**RE: NOTIFICATION OF DEFECT**

MCI 2001 through 2003 model G4500 motor coaches manufactured at Motor Coach Industries Mexico's Sahagun facility prior to unit 80518.

# Service Bulletin No. 227

MODEL G4100/G4500 Series Coaches	TYPE Field Change Program	SECTION/GROUP 12-Suspension	DATE
SUBJECT <b>RADIUS ROD BRACKETS ON FRONT AXLE LEG ASSEMBLY</b>			
CONDITIONS

Figure 4. Reference photo only, radius rod removal is required to perform retrofit steps.

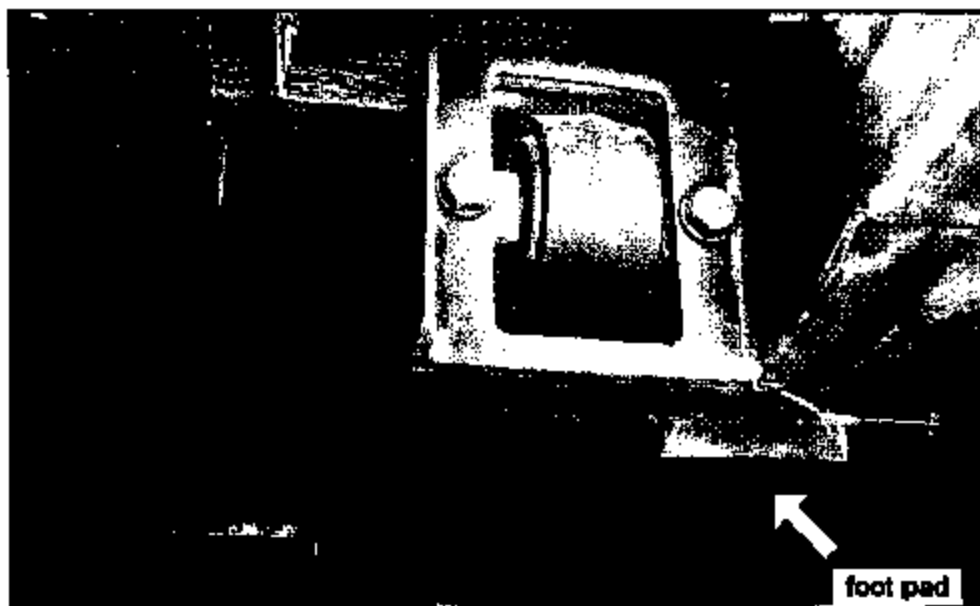
- Preheat the foot pad to 400 degrees F ( Figure 4 ). Use a temperature stick to verify that proper preheat temperature has been achieved.

Figure 5.

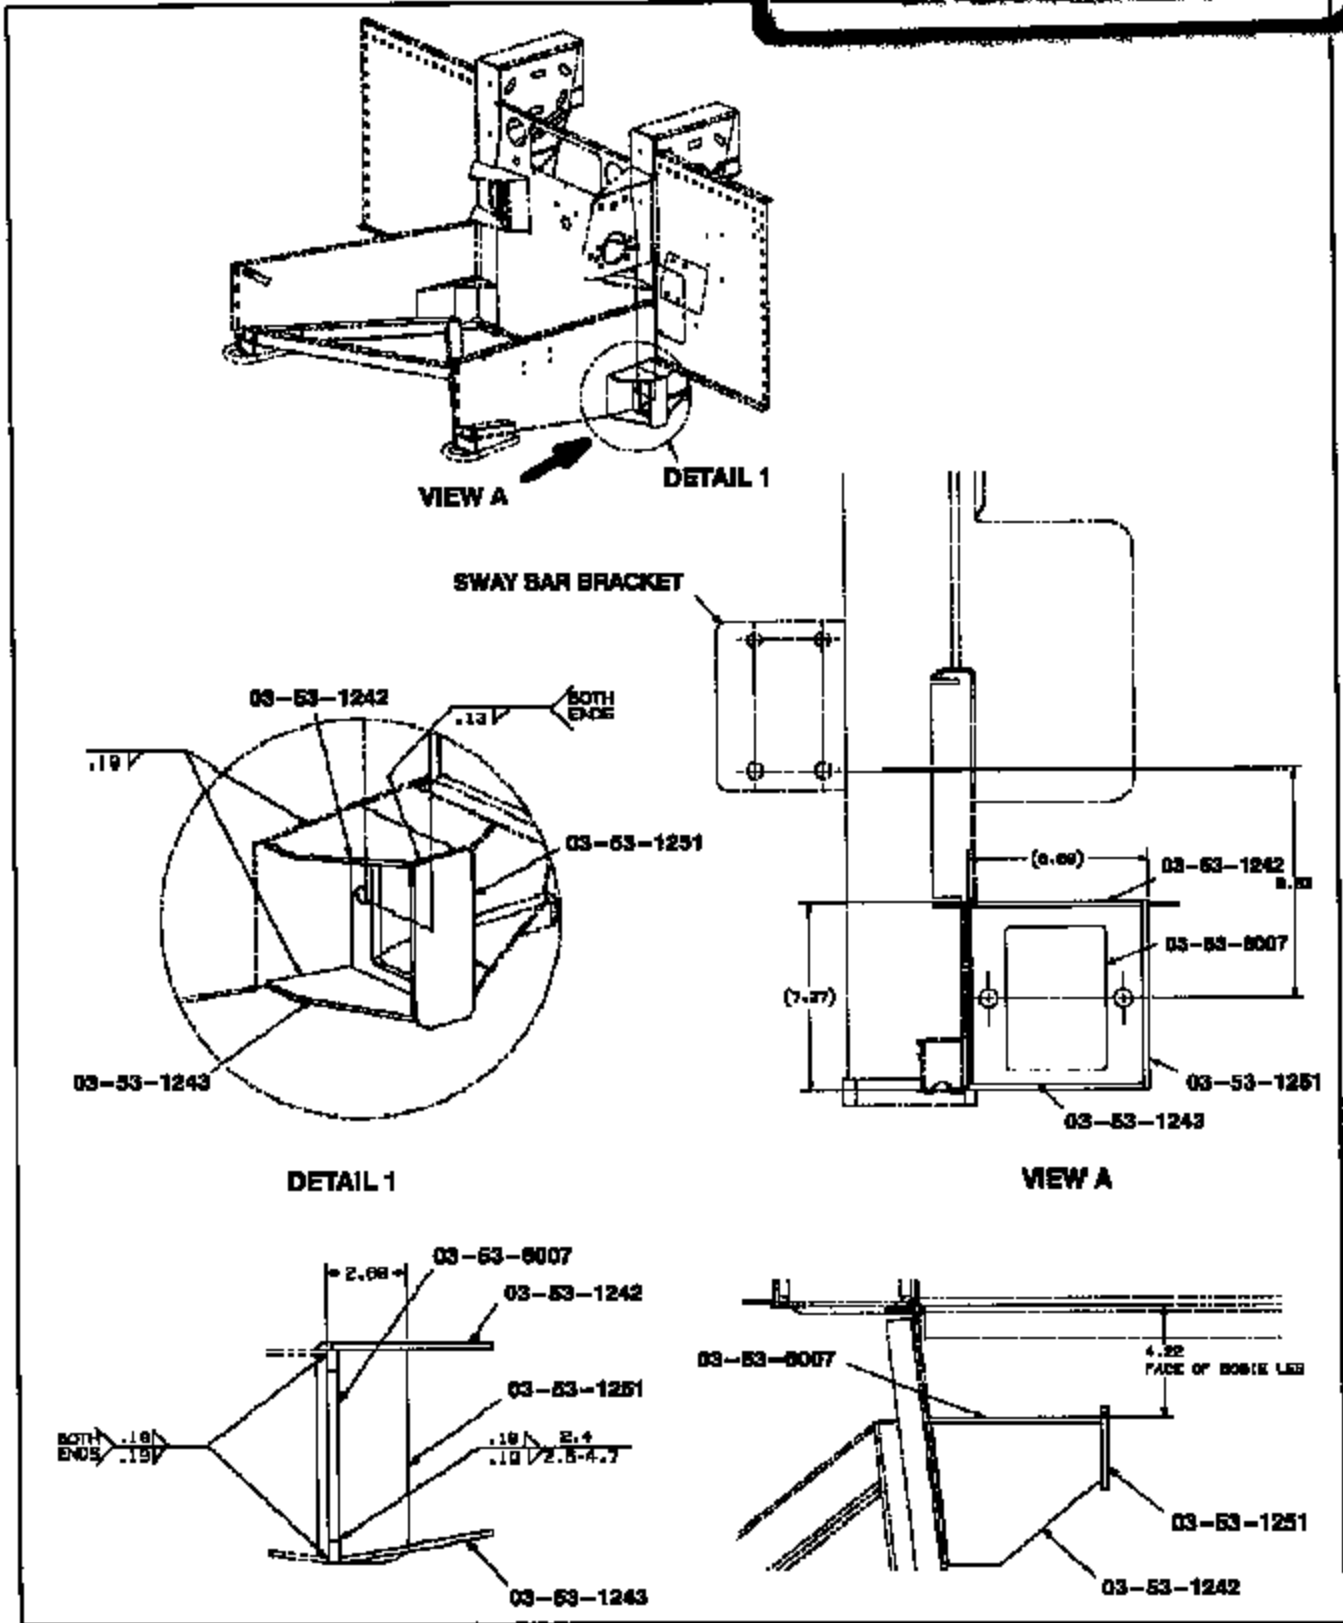
7. Visually inspect the lower radius rod bracket assembly.
8. If no cracks are present at the radius rod mounting holes and no damage to the assembly has occurred, reweld all joints according to Figure 5. Upon completion of rewelding all joints, proceed to Step 14.

- Tack weld the new support brackets and plates ( part numbers 03-53-1242, 03-53-1249, 03-53-6007 and 03-53-1251 ) into position, according to Figure 5.
- Weld the new bracket assembly to the front leg, using the weld sizes and locations in Figure 5.

Figure 7.

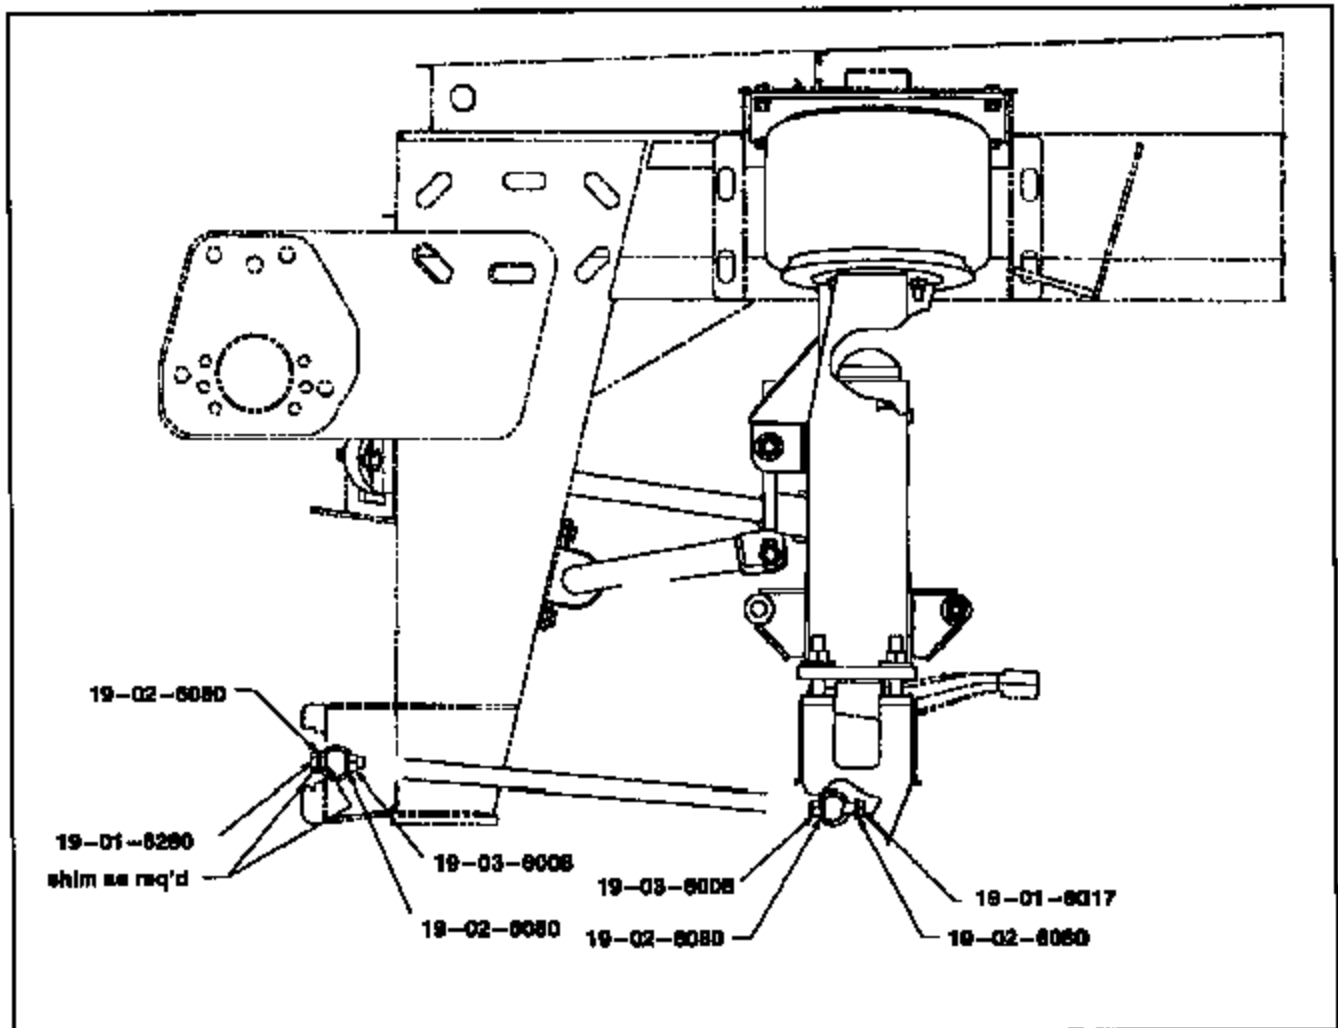
14. Using new fasteners, install radius rod according to Figure 7. Torque 19-01-6280 to 65–72 lb–ft. Torque 19-03-6008 to 171–189 lb–ft.
15. Repeat Steps 3. to 14. to opposite side.
